Ad Hoc Committee Agenda Item #:	II A – Action Item
Date:	January 23, 2020
To:	Magnolia Educational & Research Foundation dba Magnolia Public Schools (“ <b>MPS</b> ”) Ad Hoc Committee (the “ <b>Committee</b> ”)
From:	Alfredo Rubalcava, CEO & Superintendent
Staff Lead:	Patrick Ontiveros, General Counsel & Director of Facilities
RE:	MSA-1 Change Order Requests

Staff recommends and moves that the Ad Hoc Committee approve change order requests 37 to 54 up to \$176,614.96 as presented by Oltmans Construction Co. (“**Oltmans**”) for the new construction project for the benefit of MSA-1 at 18220 Sherman Way (the “**Project**”) with the payment amount to be confirmed by MPS Staff based on a review of all change order requests and back-up.

Oltmans Change Order Requests

# NOT APPROVED - CORRECTION NOTICE

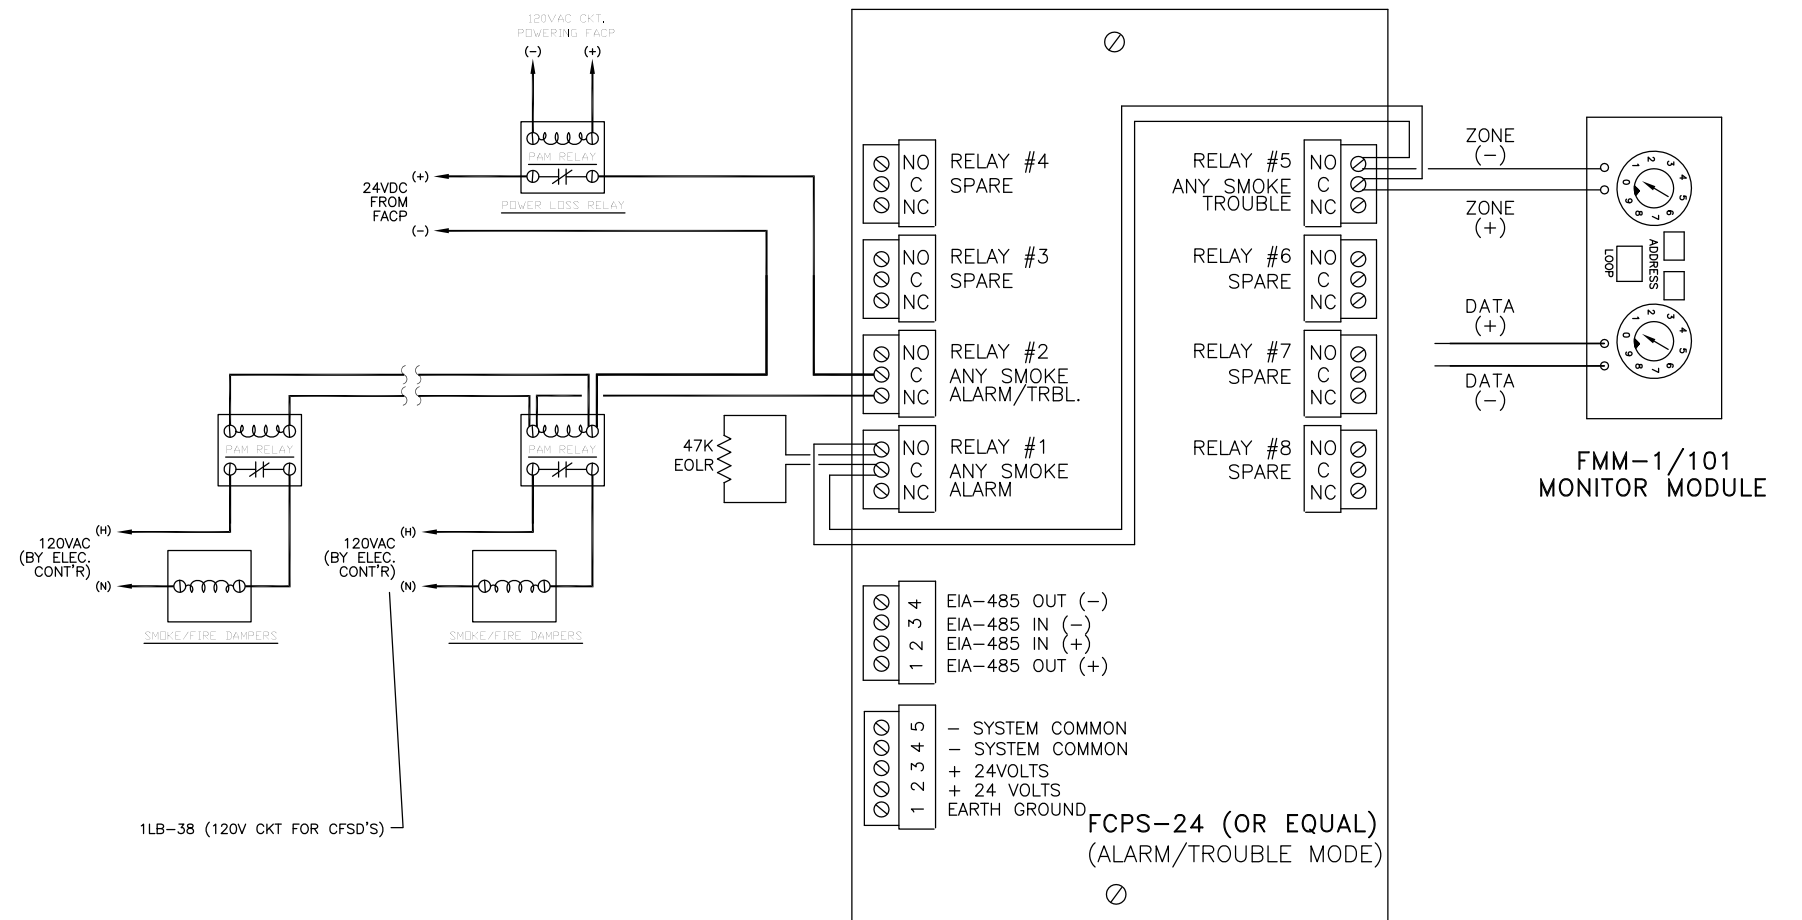
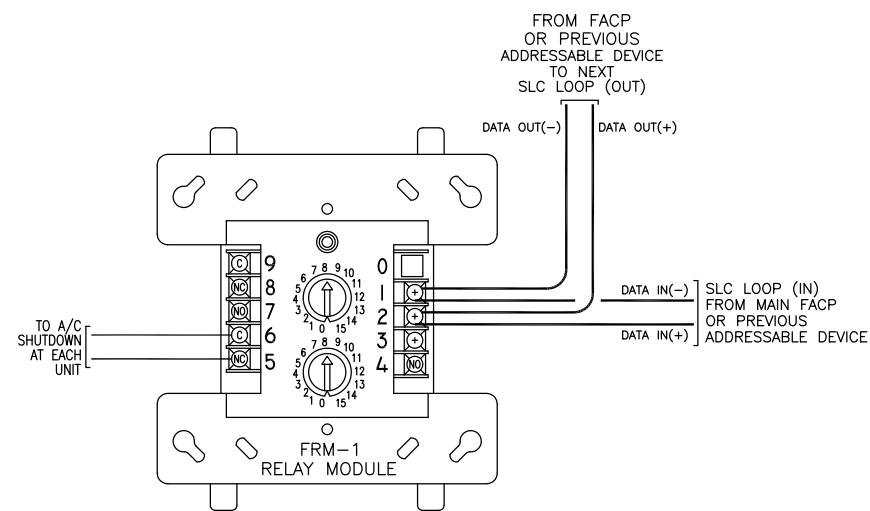
<b>JOB ADDRESS:</b> 18220 W SHERMAN WAY			<b>PERMIT #:</b> 17044-20000-07122	<b>CONFIRM #:</b> 25305989
<b>JOB DESCRIPTION:</b> HVAC			<b>FOR REINSPECTION CALL: (888)LA4-BUILD or 311</b>  <b>INSPECTOR: KEVIN BROWN</b>  <b>DISTRICT: HVACVN1</b>  <b>PHONE: (818) 374-1153</b>  <b>BUREAU: Inspection Bureau</b>  <b>DATE: 8/13/2019</b>	
<b>APPLICANT/AGENT:</b> CHRISTIAN BROTHERS MECHANICAL SERVICES INC				
<b>ADDRESS:</b> 11140 THURSTON LANE				
<b>CITY:</b> MIRA LOMA	<b>STATE:</b> CA	<b>ZIPCODE:</b> 91752		
<p>Before the work or installation authorized by this permit can be approved, concealed, energized, or used, the following deficiencies shall be corrected. Call for reinspection when all corrections have been made.</p>				
<p><b>PERMIT GROUP/TYPE/SUBTYPE: Mechanical/HVAC/Commercial</b> <b>INSPECTION TYPE: VENTILATION-Final</b></p>				
<p><b>VIOLATION NUMBER: 19-DMN-141-G-3346</b> <span style="float: right;">Date Issued: 8/14/2019</span> <span style="float: right;">Issued by</span>  <b>VIOLATION TYPE: LAMS Smoke/Fire Damper Smoke Detection</b>  <b>VIOLATION CODE SECTION: 95.606.1 LAMC</b>  <b>CODE LANGUAGE:</b> Provide duct detector within 5 feet of each smoke/fire damper in the airstream or provide full area coverage (716.3.2.1 CBC).  <b>VIOLATION NOTES:</b> Second</p>

<p><b>VIOLATION NUMBER: 19-DMN-141-G-3410</b> <span style="float: right;">Date Issued: 8/14/2019</span> <span style="float: right;">Issued by</span>  <b>VIOLATION TYPE: Fan Shutdown</b>  <b>VIOLATION CODE SECTION: 95.609.0 LAMC</b>  <b>CODE LANGUAGE:</b> Provide duct detector in the main supply air plenum of all air moving systems in excess of 2000 CFM combined, such systems shall shutdown simultaneously without delay.  <b>VIOLATION NOTES:</b> Second</p>

**1 WEST WALL**

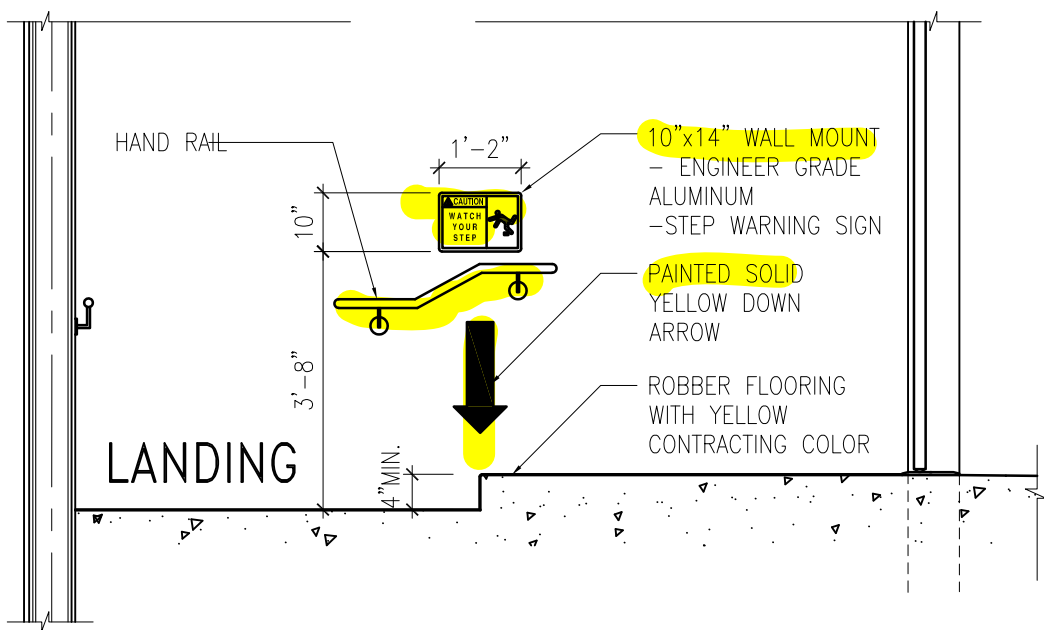
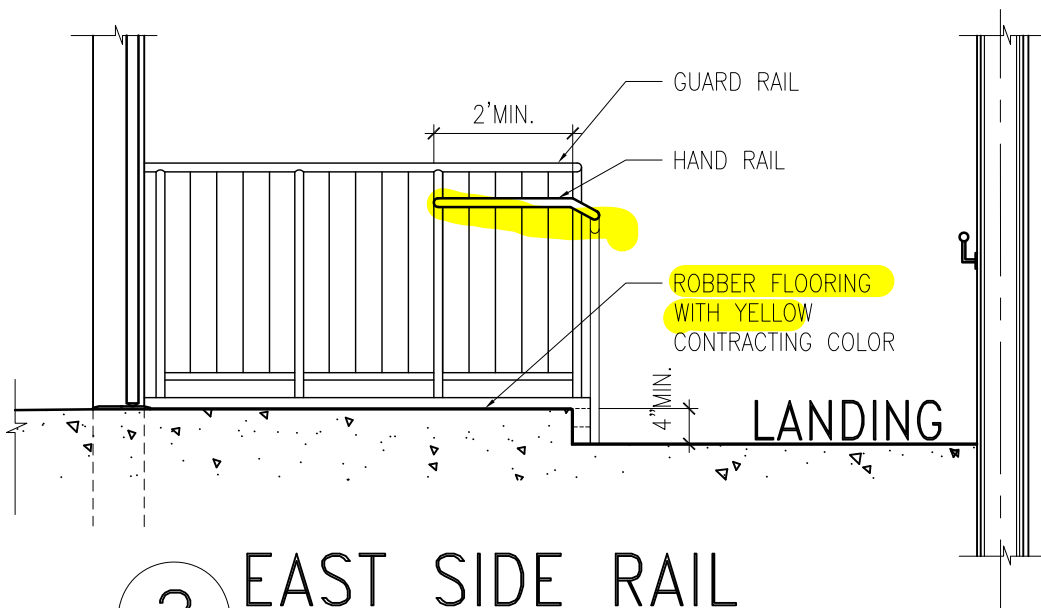
3. Adjust hand railing at the landing due to added step (stair #2, roof top only) on the previously approved shop drawing 051200-03 Stairs Shop Drawings FAC 071018.

Add hand rail & backing per jobsite walk after OAC 5/8/19.

Change hand rail & backing per jobsite walk after OAC 5/8/19.

See attached SK-040.

8/A9.3 - RFI 173 Chem Lab #201

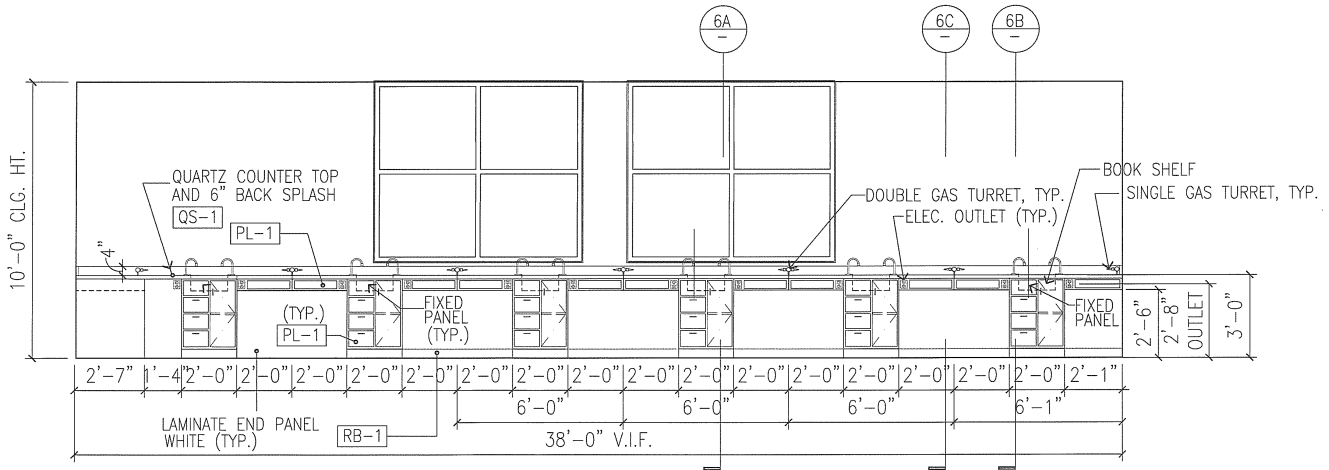
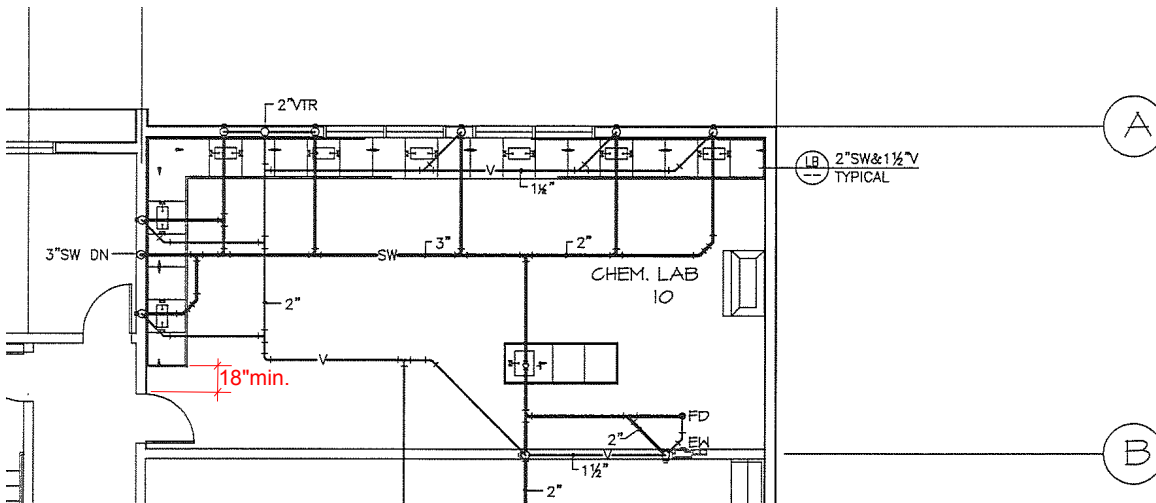
The Chemistry Lab room #201 has full height windows facing North above the lower cabinets. See A9.3 detail 8. The windows are type "A" found on A10.1. The plumbers have no way to run their waste and vents. We have large structural beams above and below. The 18" cavity between the windows are full of structural posts etc. There is no room to run a vent or waste up or down this 18" cavity.

Provide about 4" full-height furring on north wall to accommodate the plumbing work.

Adjust the cabinet work at the north-west corner.

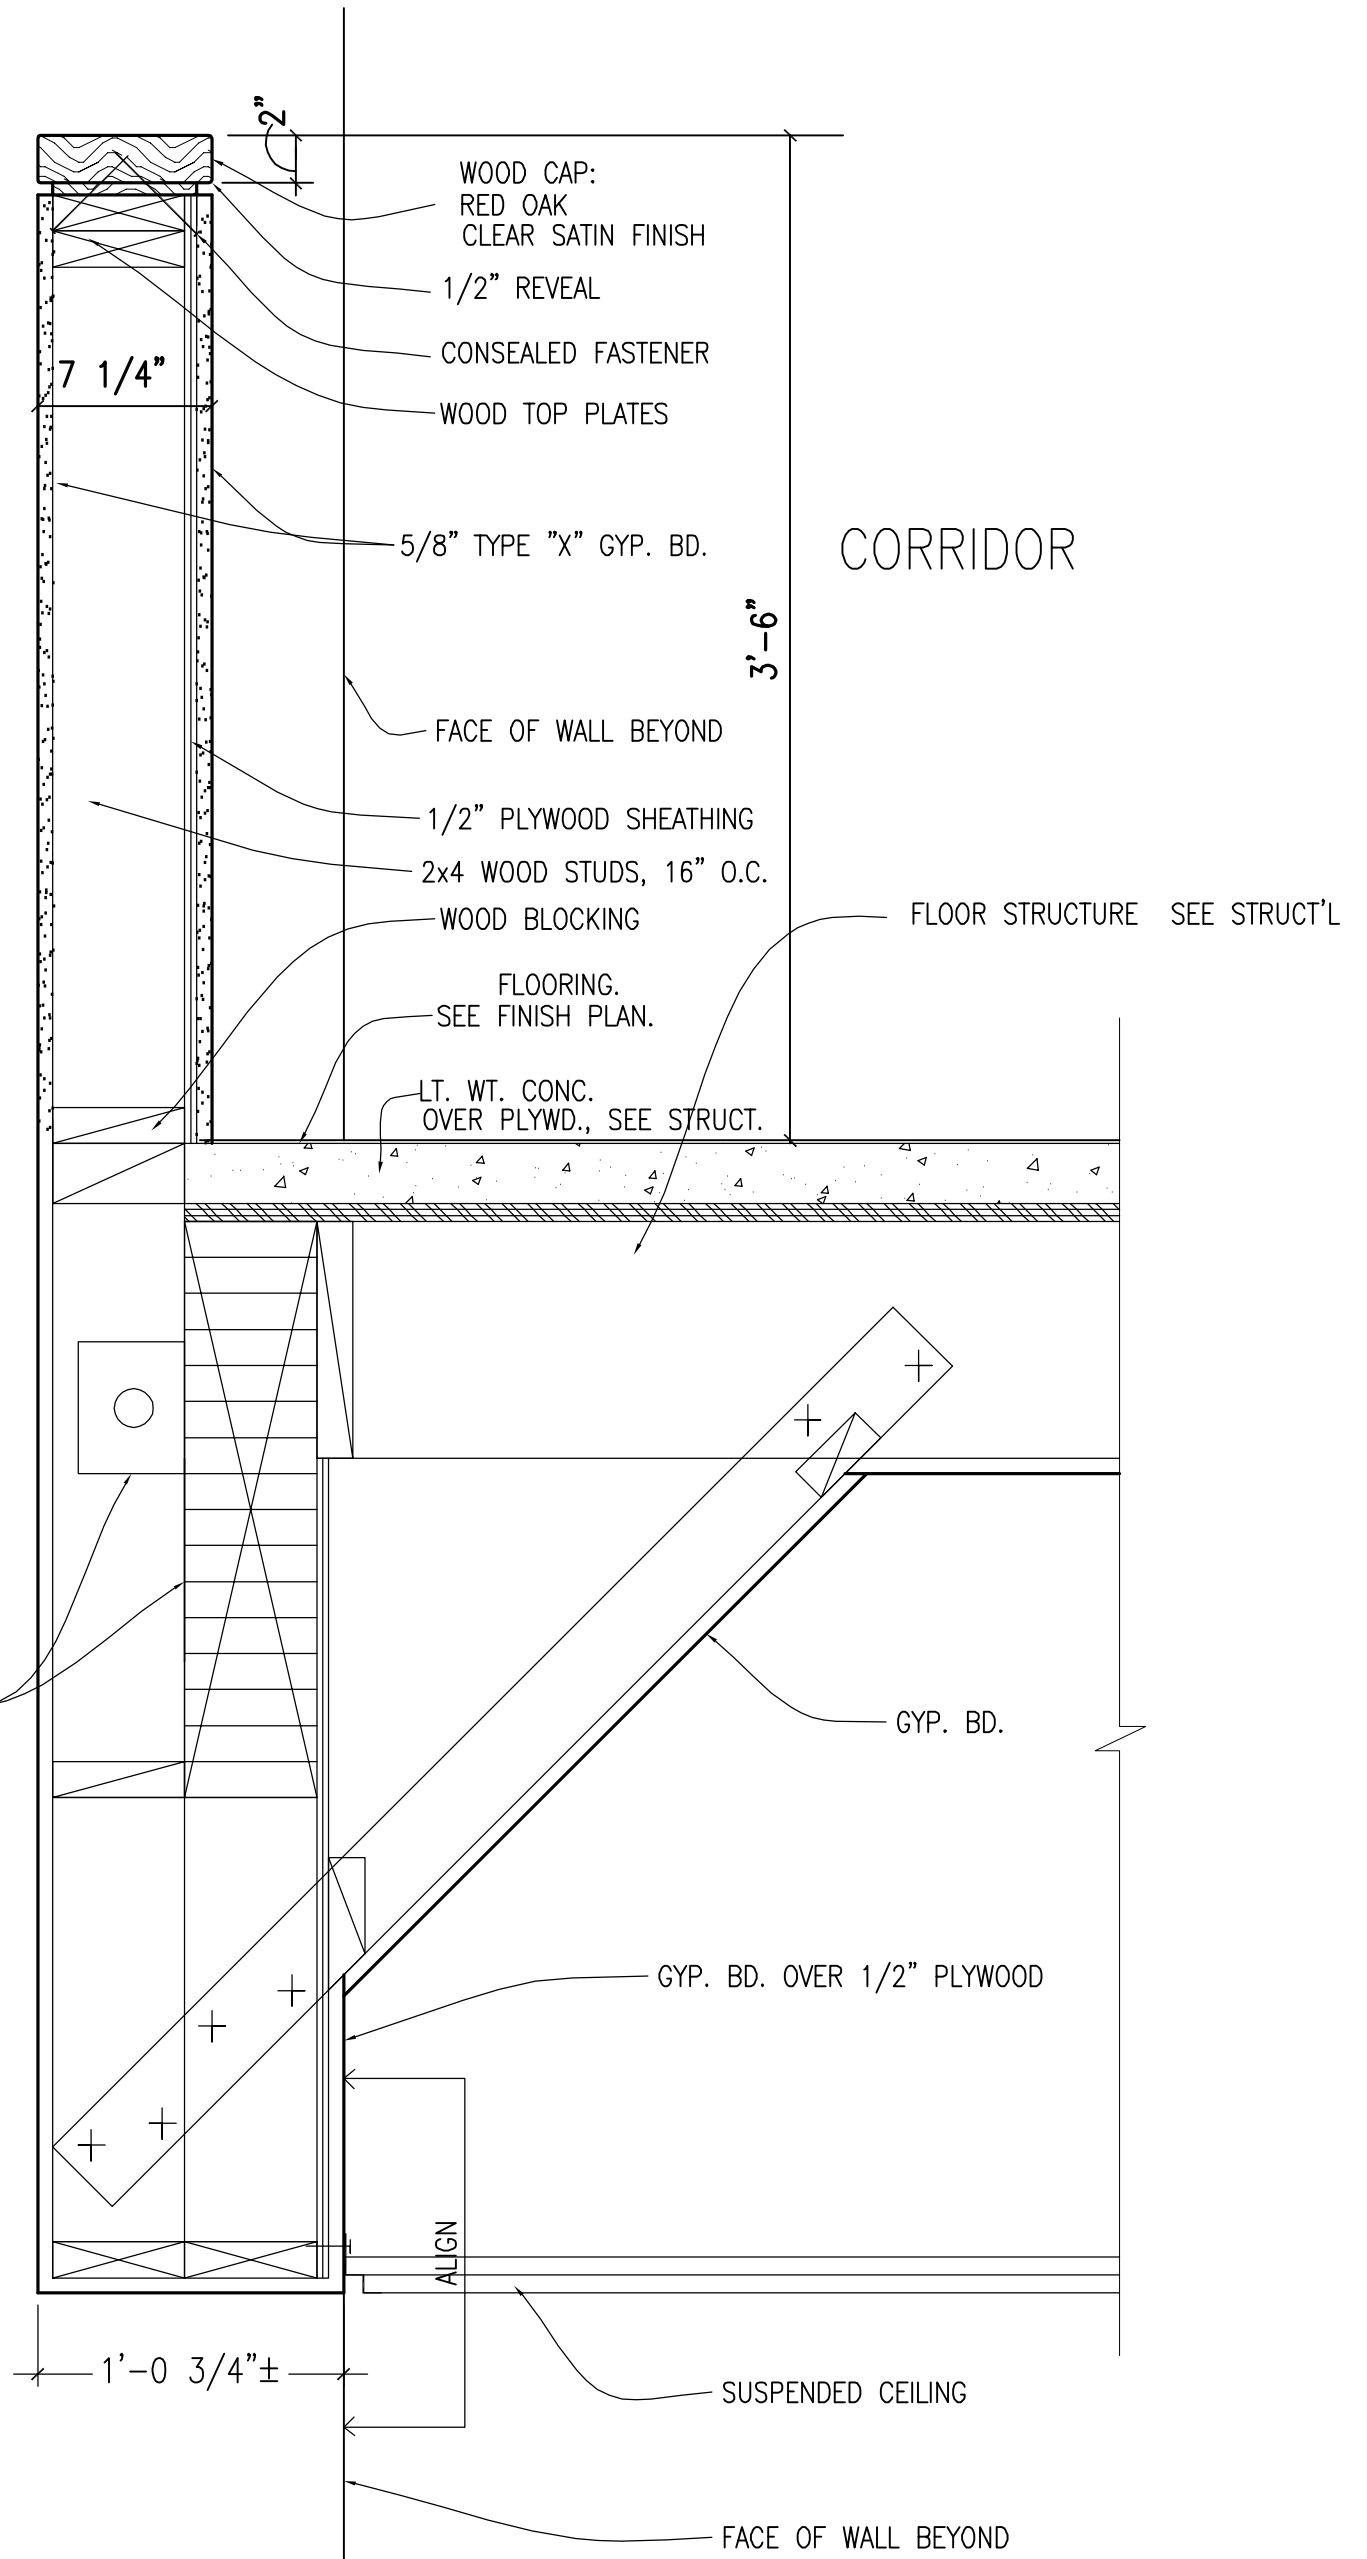
As discussed with Johann at job walk 3/20/19: At 2nd floor 2/ A6.2 shows the low wall on top of the beam; this is the incorrect detail. Sheet S6.3 detail 11 shows the low wall / curtain wall bolting to the beam; this is the correct detail we followed. The bottom of the curtain wall needs to be widened by 6". Please confirm.

Follow SK-034 which was submitted with RFI #129. This is confirmed.

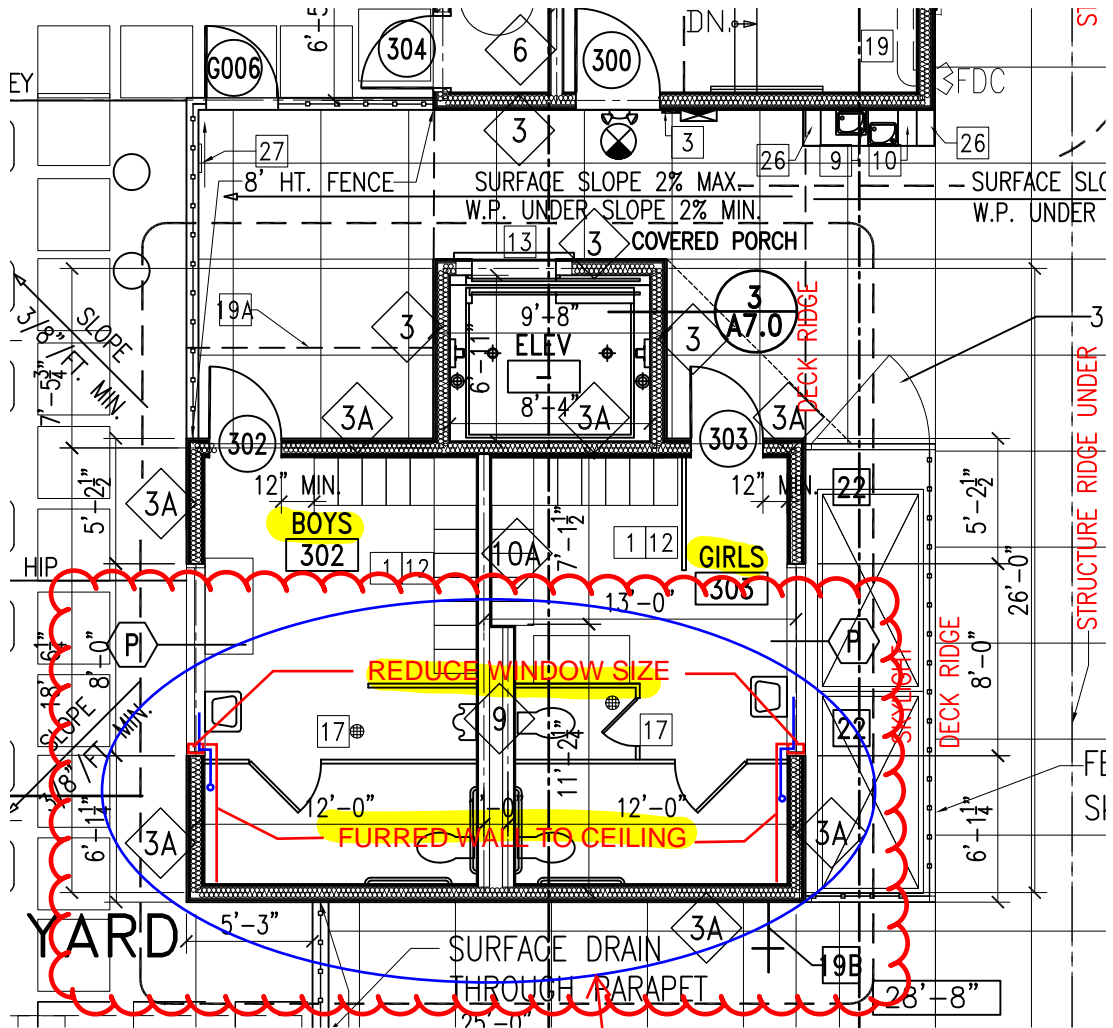
**FUR WALL AND REDUCE WINDOW SIZE AS NECESSARY TO ACOMODATE THE VENT.  
SEE MARKINGS BELOW.**
